service bulletin

Bulletin No. 2002-08

New Thermostats and Thermostat Covers 3.0 Liter

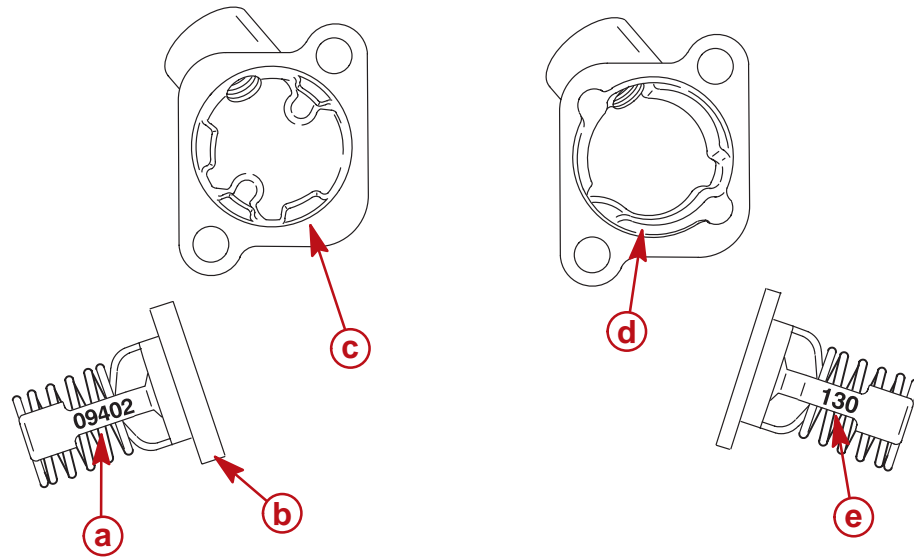
The 120° F [49° C] thermostat P/N 850279 2 currently used on the above listed models has been made No Longer Available (NLA) and is being replaced with a 130° F [54° C] thermostat. The new thermostat has a thicker seal, which is bonded onto the thermostat. The thicker seal on the new thermostat will require the use of a new thermostat cover.

For standard production outboards (non Hi-performance) order new 130° F [54° C] thermostat **P/N 885599 1** to replace the 120° F [49° C] thermostat and order the required thermostat cover from the list below.

NOTE: Kit P/N 885599A1 is available for the 2000 and Newer Optimax engines that includes both port and starboard covers, two cover gaskets and two 130° F [54° C] thermostats.

59179

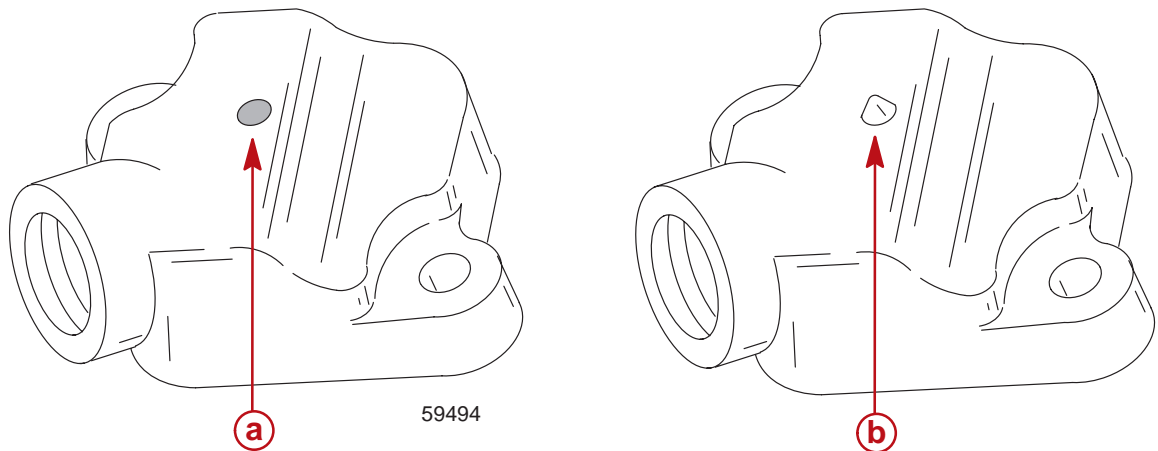
- Some early replacement covers had no marking on the outside of the cover and can only be identified by looking at the inside of the cover. Look for narrower support ribs on the new style covers. Later replacement covers had a WHITE paint dot or a raised dot on the cover.

- a** - Typical date code stamping
- b** - Thicker rubber seal new style thermostat
- c** - New cover with narrower support ribs
- d** - Old cover with wider support ribs
- e** - Temperature rating stamped on thermostat
